TOMAS KRUKAITIS  
5483 HARRIS FARM LA.  
CLARKSVILLE, MD. 21029

PROPOSED 4 CAR GARAGE

5483 HAMMIS  
FORM 40

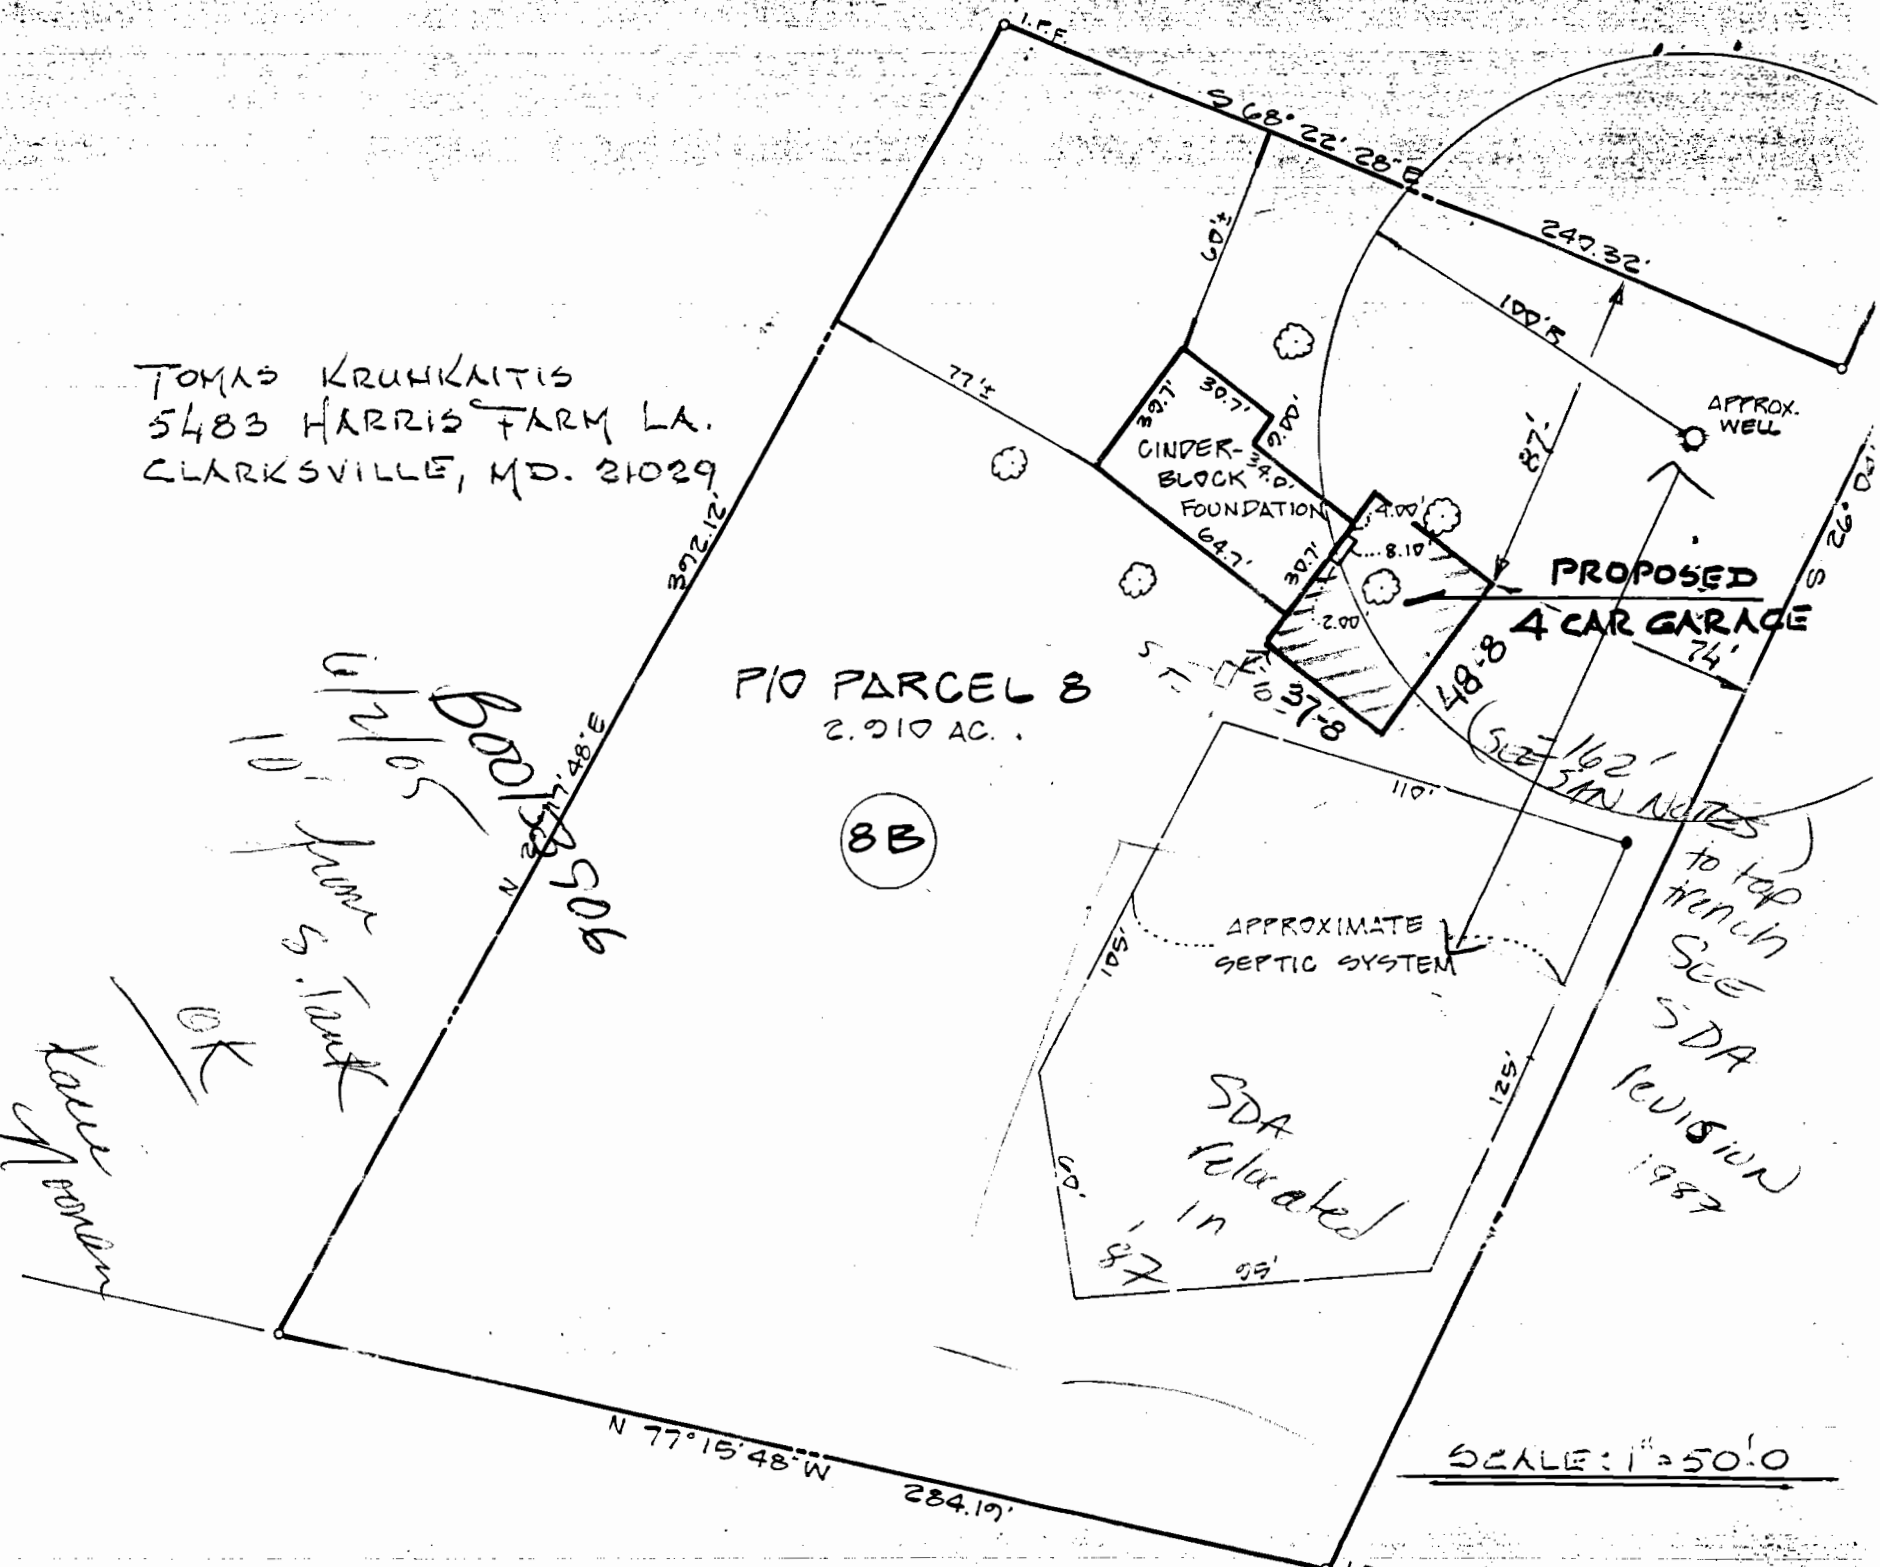
SDA relocated

to top trench  
SEE SDA REVISION 1987

*OK*  
*have problem*  
*10' from S. Tank*  
*600' x 90'*  
*307' x 48'*

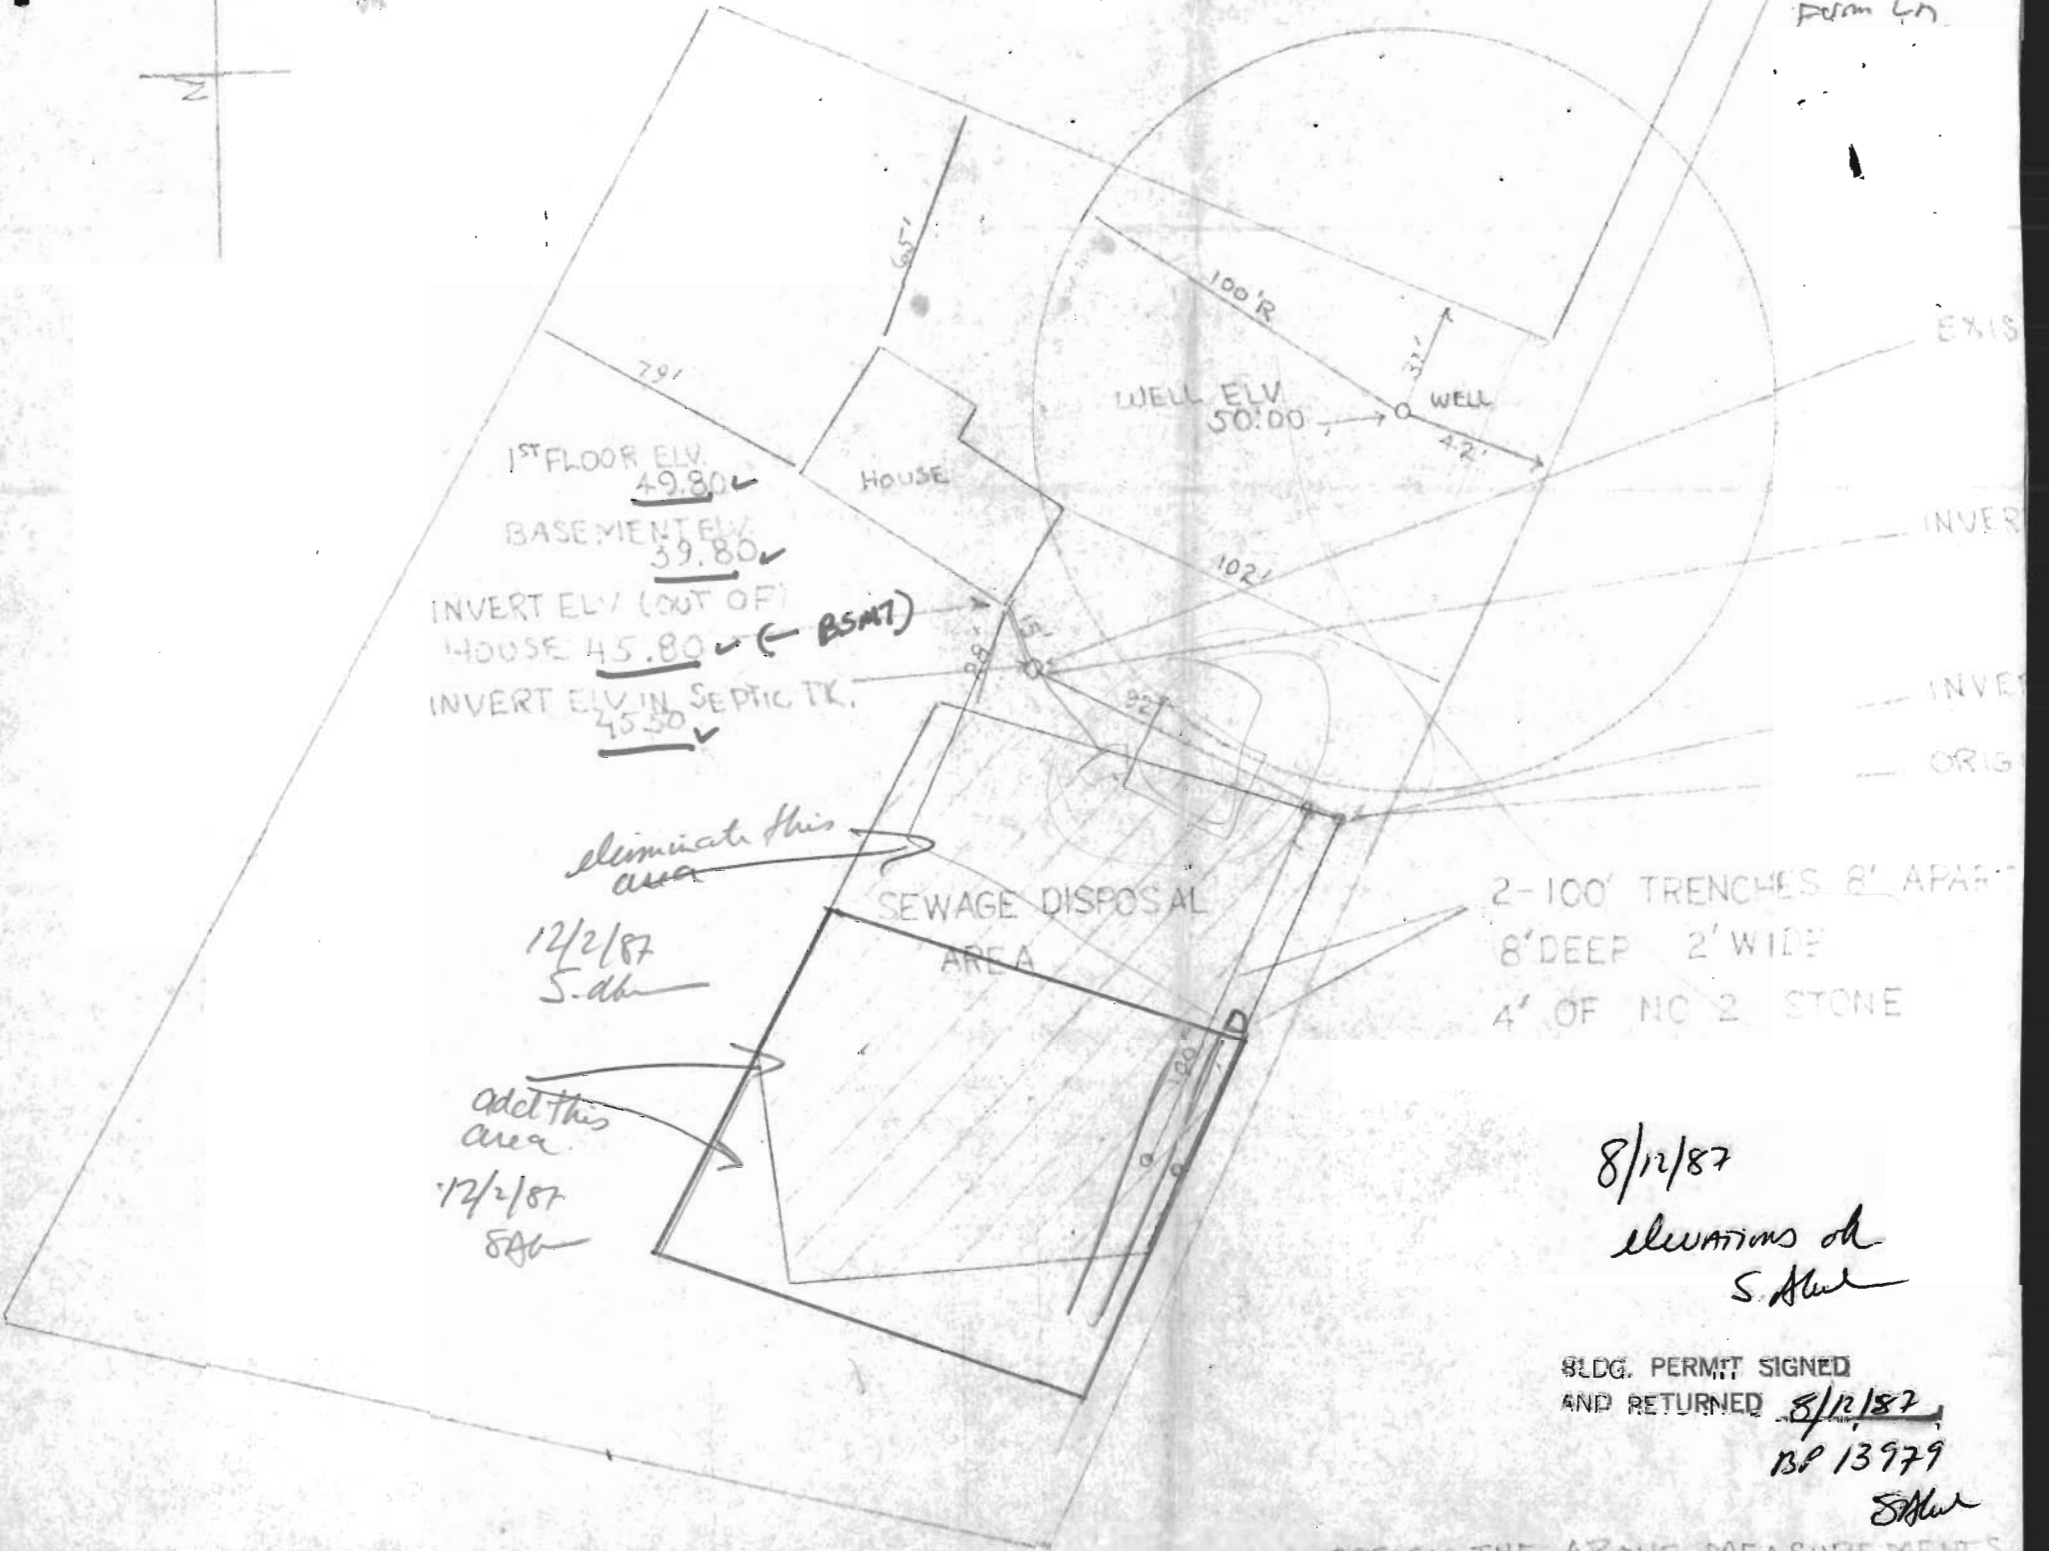
*eliminate this area*  
12/2/87  
S. db

*add this area*  
12/2/87  
S. db

PLEASE VERIFY THE ABOVE MEASUREMENTS

2-100' TRENCHES 8' APART  
8' DEEP 2' WIDE  
4' OF NO 2 STONE
